ADDENDUM # 01	
Issued by/Contact Name	Andrea Kozak Engineering Coordinator Town of High River
Addendum Issue Date	July 23, 2020
Email and Phone Number	<a href="mailto:engineering@highriver.ca">engineering@highriver.ca</a>
RFP Package Name and Description	Back Lane Repaving Downtown between 3 <sup>rd</sup> and 4 <sup>th</sup> Ave SW
RFP Package Issue Date	July 15, 2020
Instructions	Acknowledge receipt of Addendum #01 in Proposal Submission
Attachments	Revised Appendix "3" – Rate Schedule, revised site drawings
Issued to	Prospective proponents

# BACK LANE RE-PAVING DOWNTOWN ISSUED FOR TENDER

PROJECT NAME: **TOWN OF HIGH RIVER BACK LANE RE-PAVING DOWNTOWN HIGH RIVER, ALBERTA**

SHEET TITLE: **LANE GRADING PLAN**

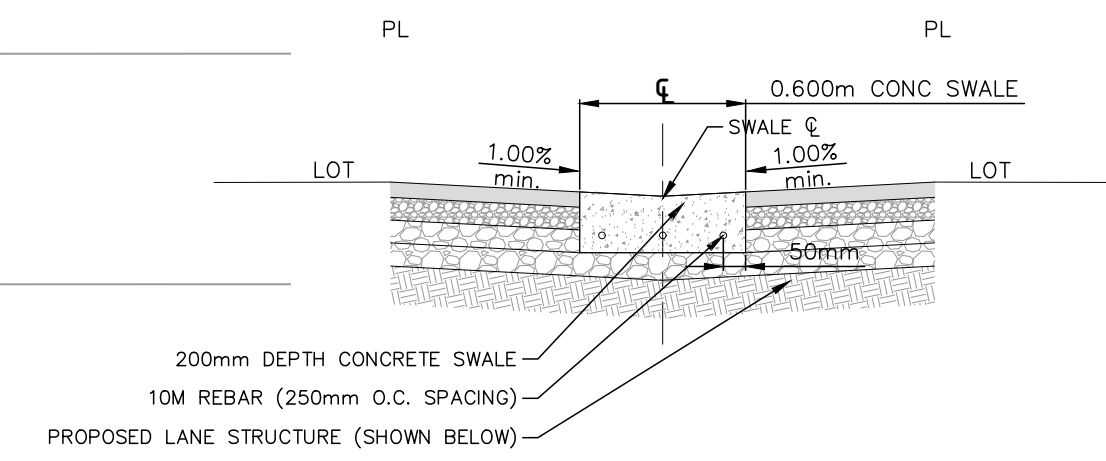
Note from the Town: Full width of breezeway to the to be included in scope of work for paving. Existing paving stones to be removed.

Note from the Town: Area to be included scope of work for paving.
